Three Mile Island Nuclear Station, Unit 1
Renewed Facility Operating License No. DPR-50
NRC Docket No. 50-289

Subject: First Six-Month Status Report in Response to March 12, 2012 Commission Order Modifying Licenses with Regard to Requirements for Mitigation Strategies for Beyond-Design-Basis External Events (Order Number EA-12-049)

Three Mile Island Nuclear Station, Unit 1 First Six Month Status Report for the Implementation of Order EA-12-049, Order Modifying Licenses with Regard to Requirements for Mitigation Strategies for Beyond-Design-Basis External Events

CADD FILE NAME: 10-010-F-01-REVISED		DATE: 07/19/13	
THIS IS A COMPUTER GENERATED DRAWING DO NOT REVISE IT MANUALLY			
Evolve			
TM FLEX FLOW DIAGRAM DIESEL GENERATOR SYSTEM			
SCALE: NOT TO SCALE	DATE: 10-01-03	REV: 0	NA
FILE NO.	DATE	REV	NA

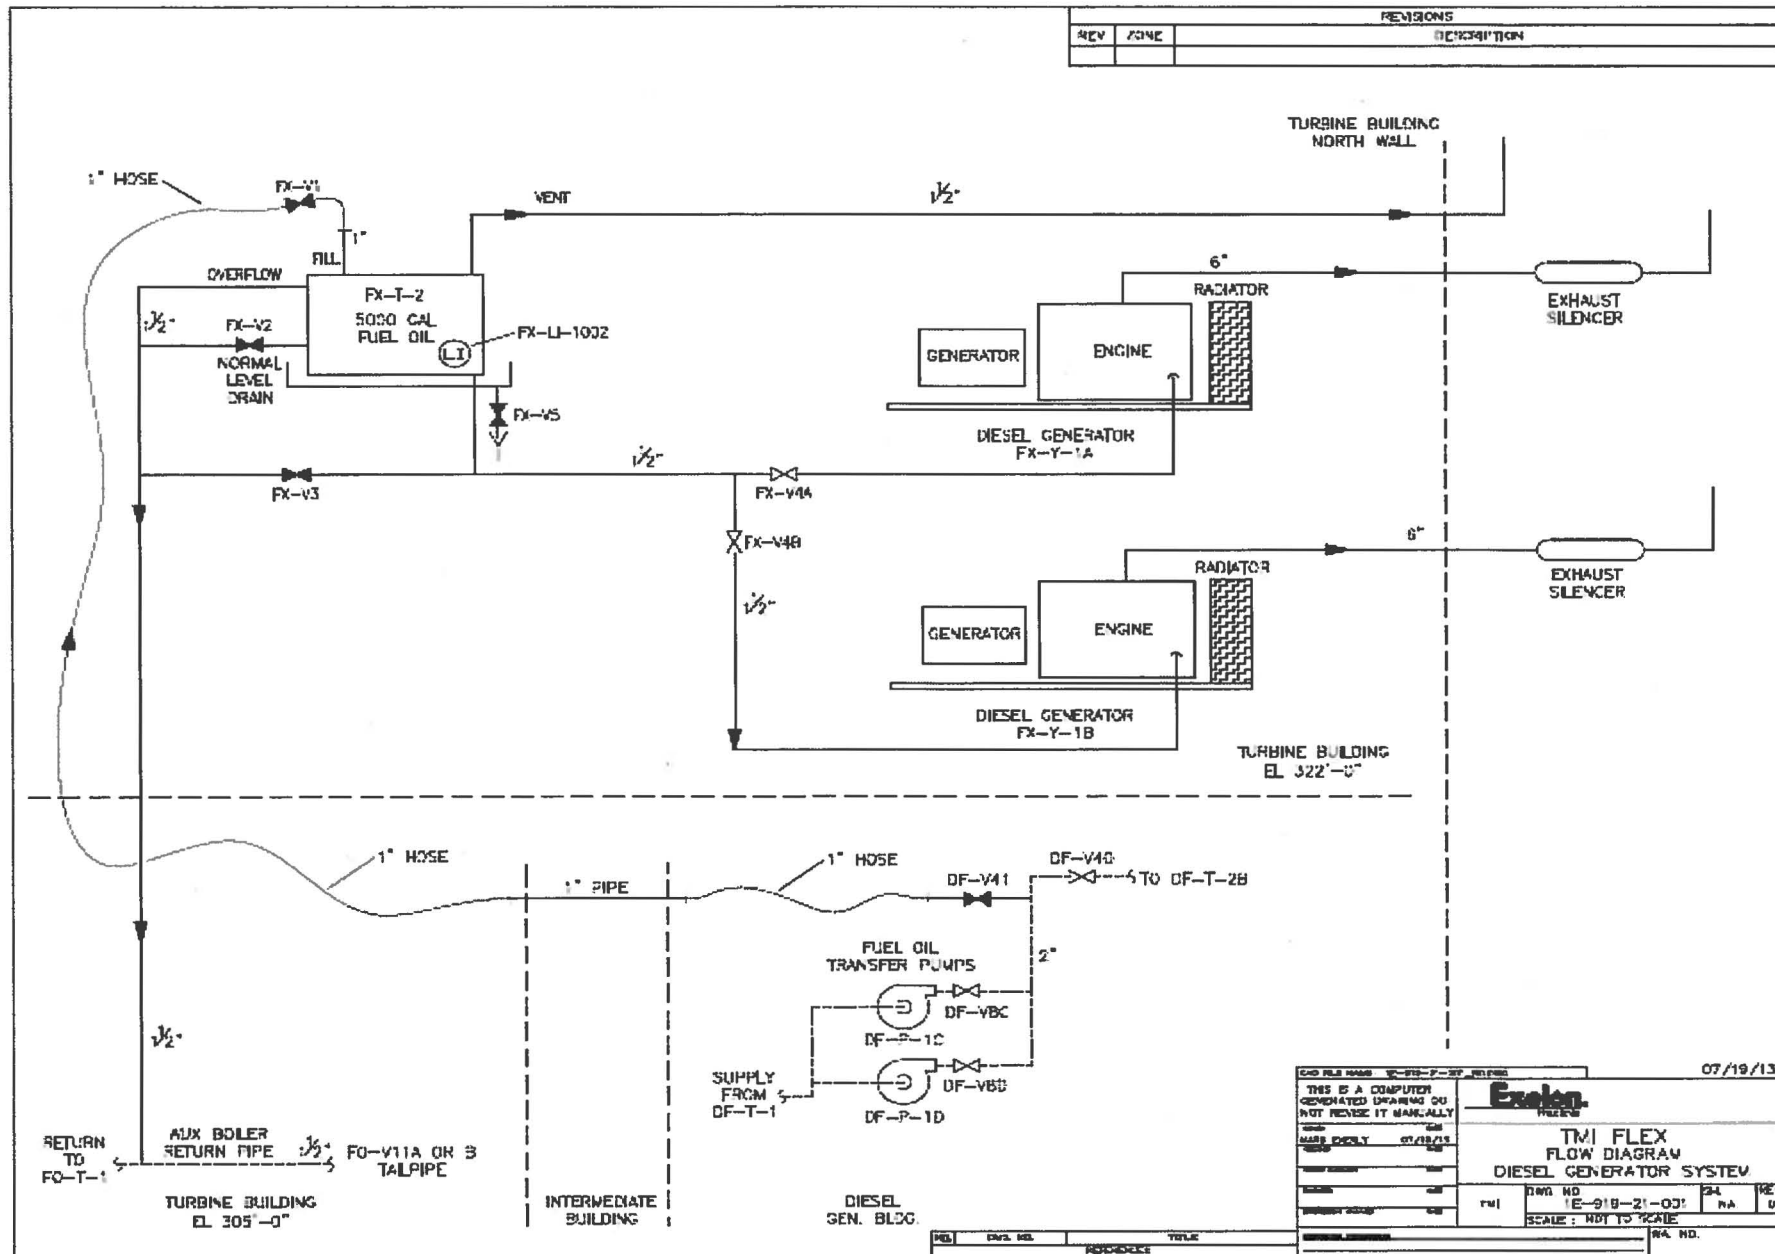
- FLEX Diesel Generator Fuel Oil (Reference 1E-919-21-001, DRAFT, attached)

- One (1) 5000 gallon fuel oil tank replaces the two (2) 2600 gallons fuel oil tanks. This 5000 gallon tank will normally contain 100 gallons, enough to start and initially load the generators.

- Fuel oil tank supply is provided from 30,000 gallon underground tank (DF-T-1) using DF-P-1C or DF-P-1D.
- FLEX Electrical Generation and Distribution (Reference 1E-919-21-002, DRAFT, attached)
